**UV REPLACEMENT AT HAVERSTRAW ELEMENTARY SCHOOL**

**MSA File No. 41048**

**NOTICE TO BIDDERS**

**Re: ADDENDUM NO. 5**

g Title	g No.
<b>DETAILS</b>	<b>A-500</b>

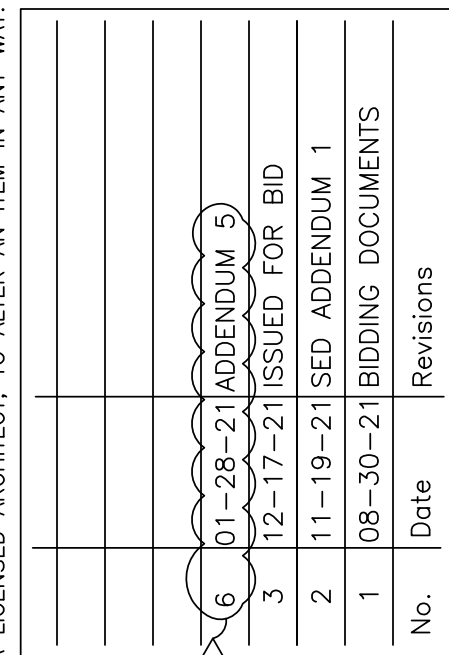
- 4) There shall be no exposed electrical conduit running throughout the building. On the first and second floor corridors, all conduit and cables shall run above the existing ceilings. On the first and second floor classrooms and offices, wherever the ceiling is not accessible, the power shall be installed in the line set enclosure. On the third floor all line sets, combiner boxes, and electrical conduit are run in the attic and drop vertical to the UVs. The vertical drops shall be within a line set enclosure. See attached revised detail 6/A-500 Line Set Enclosure.

E-060

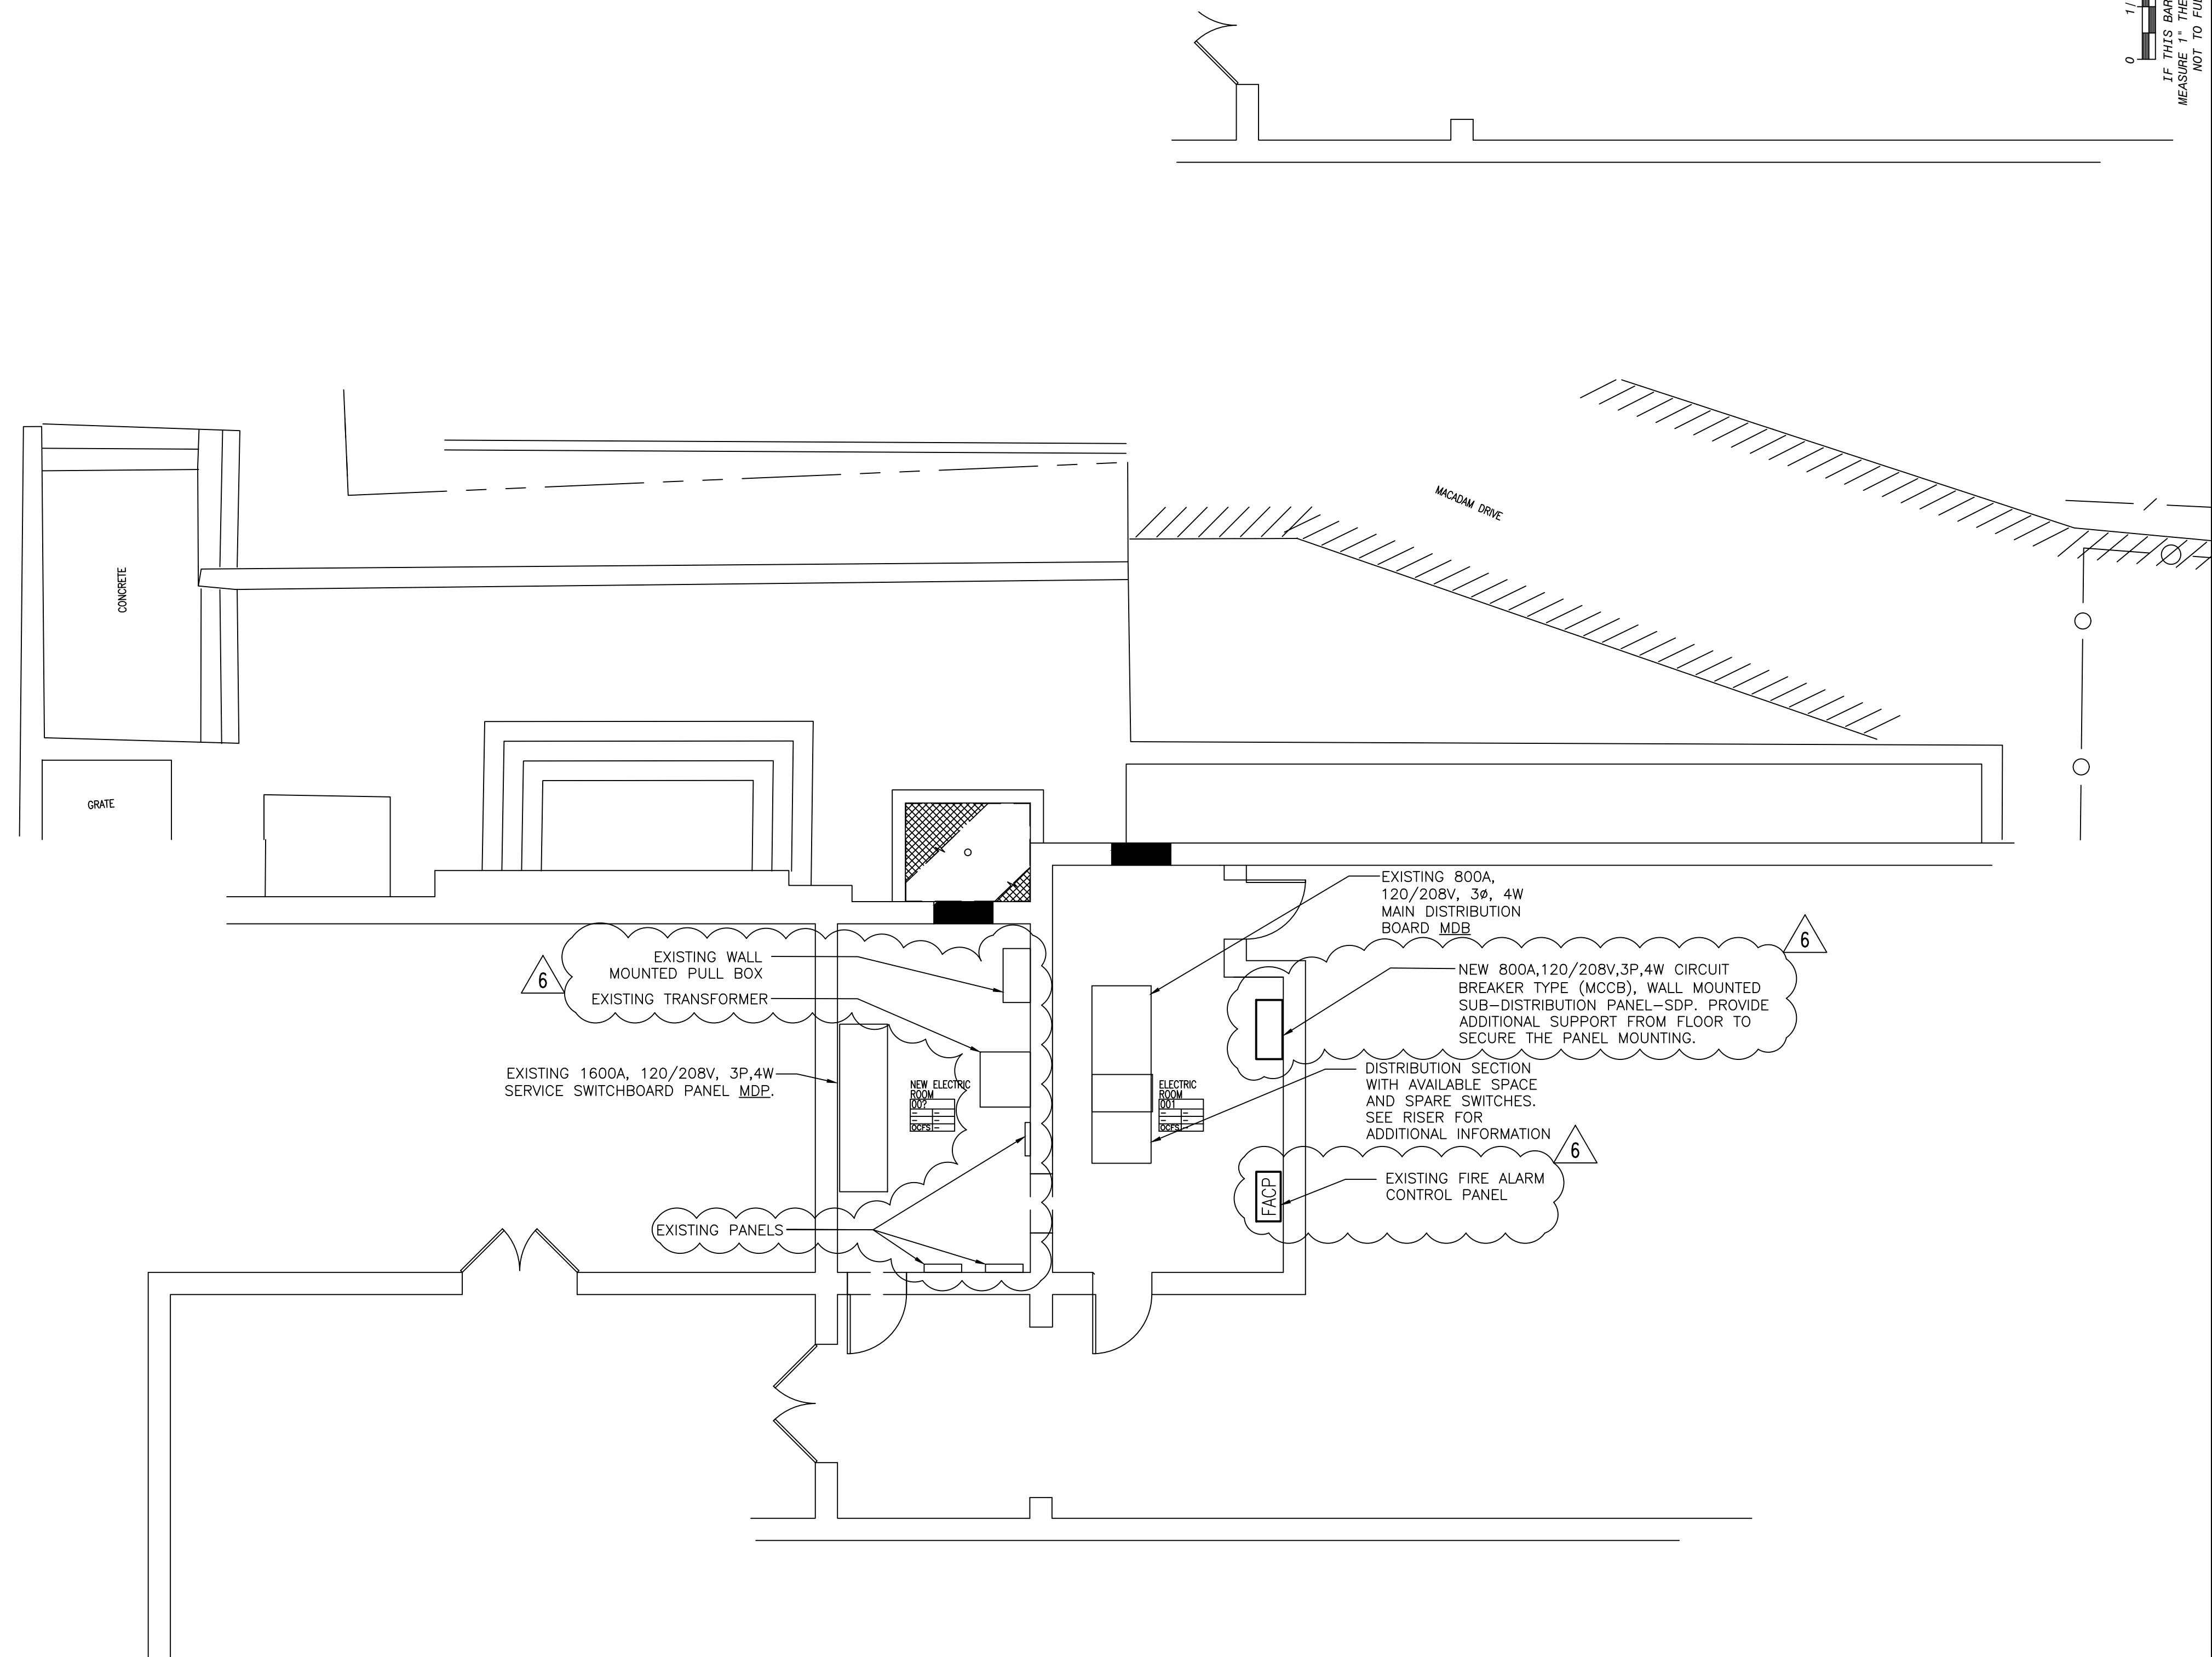
- 10) See attached revised drawings E-060, E-100 and E-201 dated 01/28/22. Location for sub-distribution panel has been revised to be in Electric Room 001. Remove originals and replace with attached.

- Demolition Note:** A cloud-shaped callout points to a small rectangular area on the right, stating: "REMOVE EXISTING ABANDONED TELEPHONE BOX AND ASSOCIATED WIRING AND CONDUIT BACK TO SOURCE IN ORDER TO MAKE THE SPACE AVAILABLE FOR INSTALLATION OF NEW ELECTRICAL PANEL."
